## ADDENDUM NO. 4

PROJECT: Frenchtown Entry Station Rehabilitation

FWP PROJECT #: 7196145

DATE: 2/16/23

**SITE ELECTRICAL DRAWING**

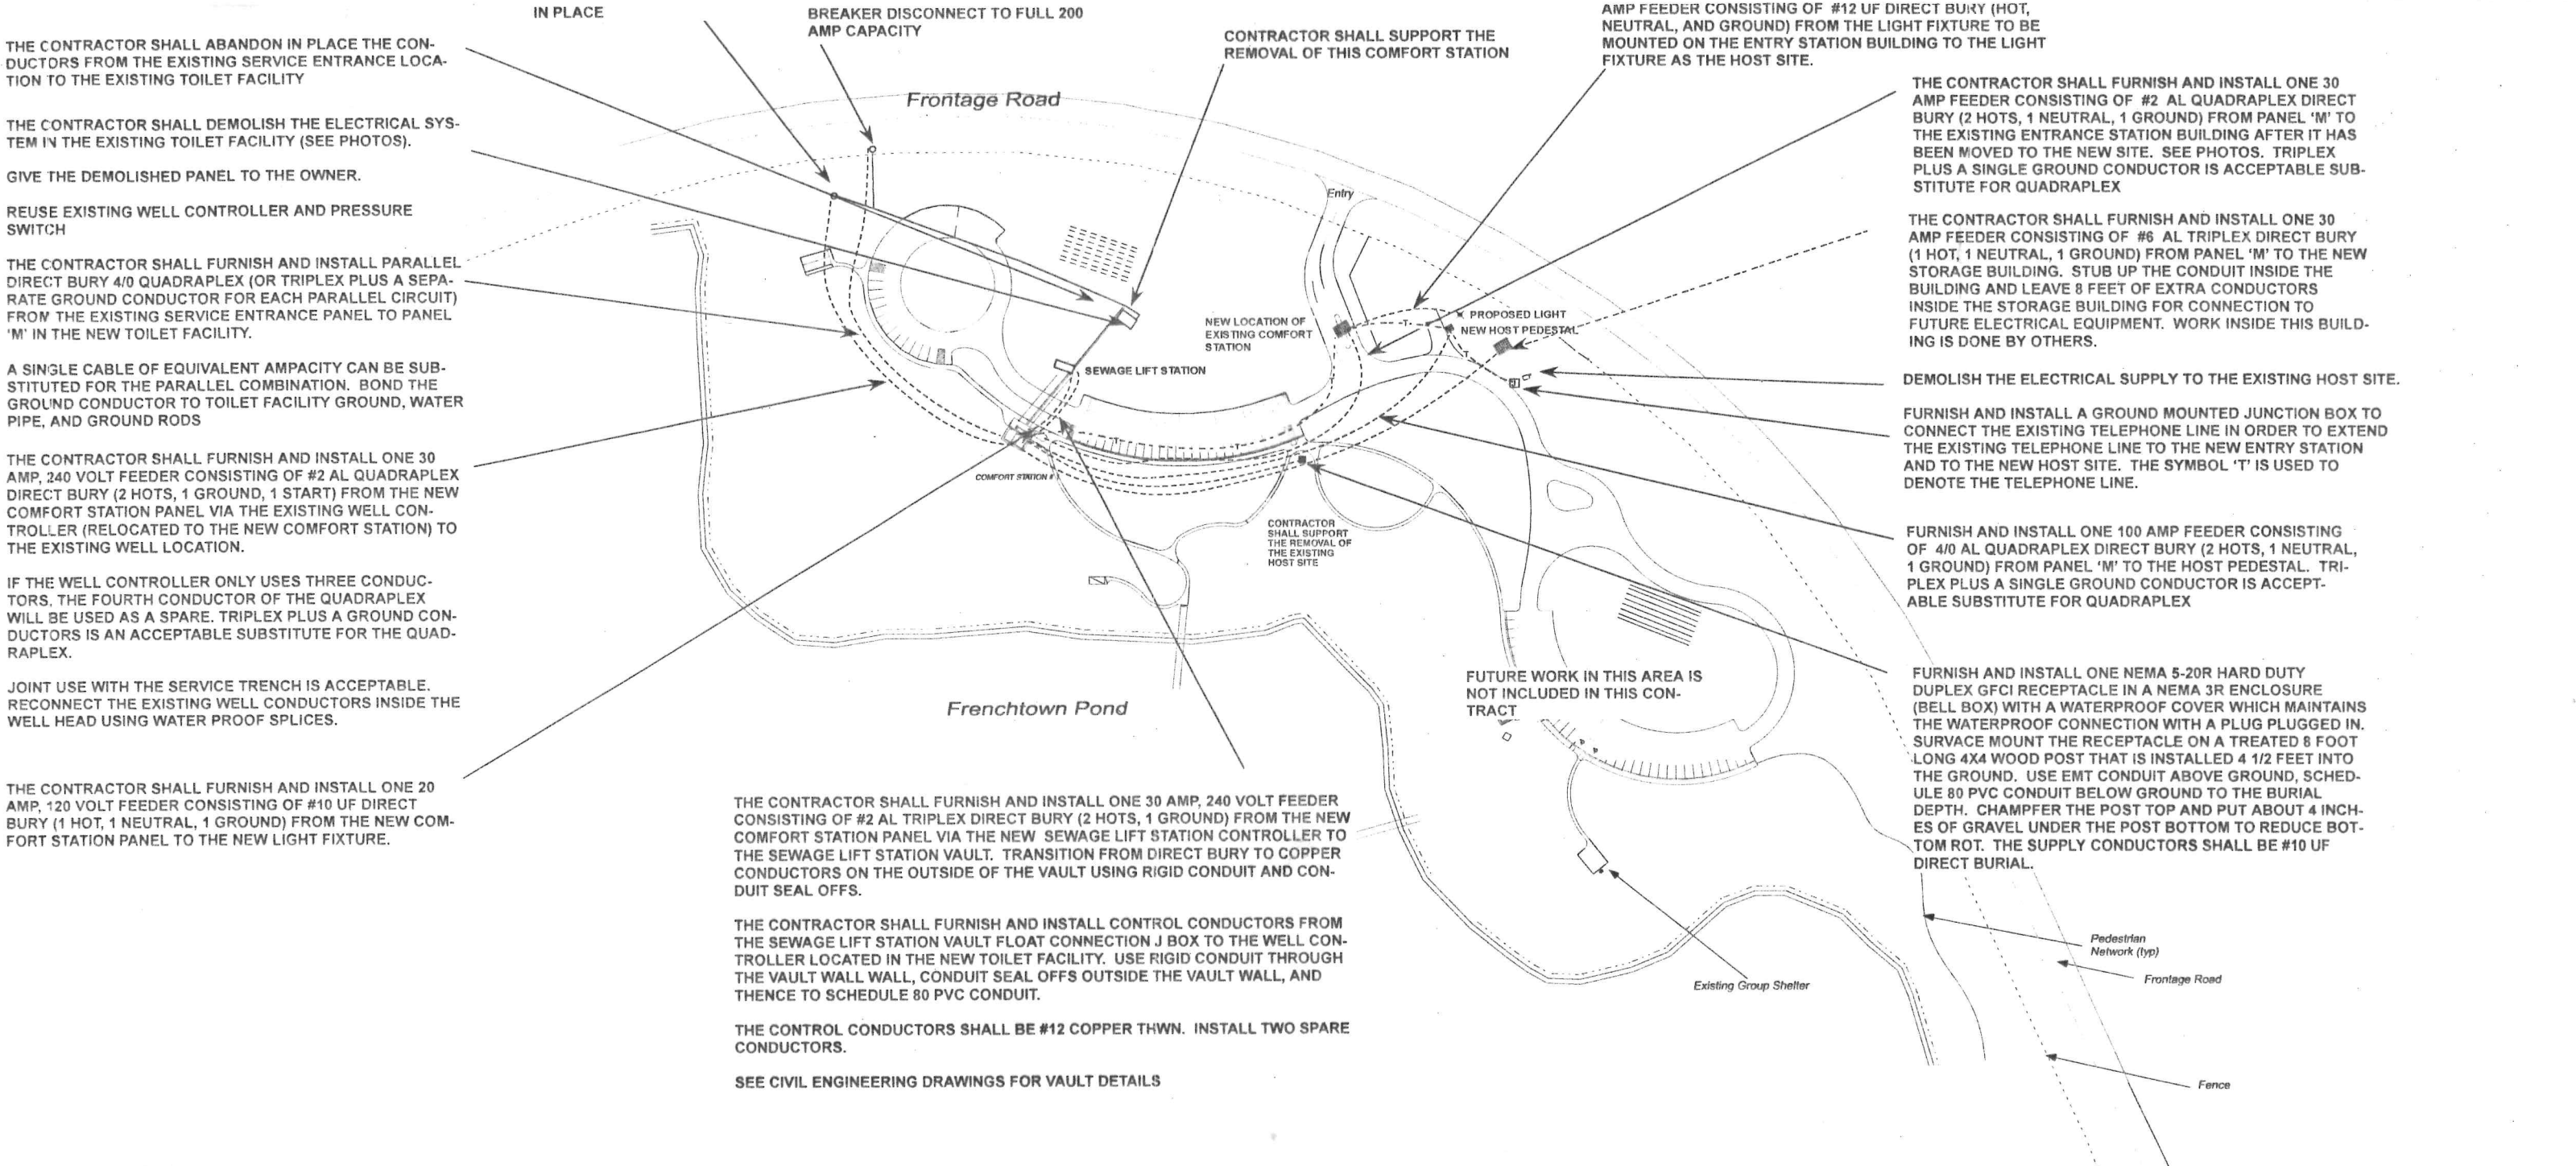
- **Electrical service to be trenched from existing location to the outside of the new structure.**
- **Site plan attached showing existing electrical site plan throughout the park.**
- **Replace: Existing proposal sheet with new revised proposal sheet.**
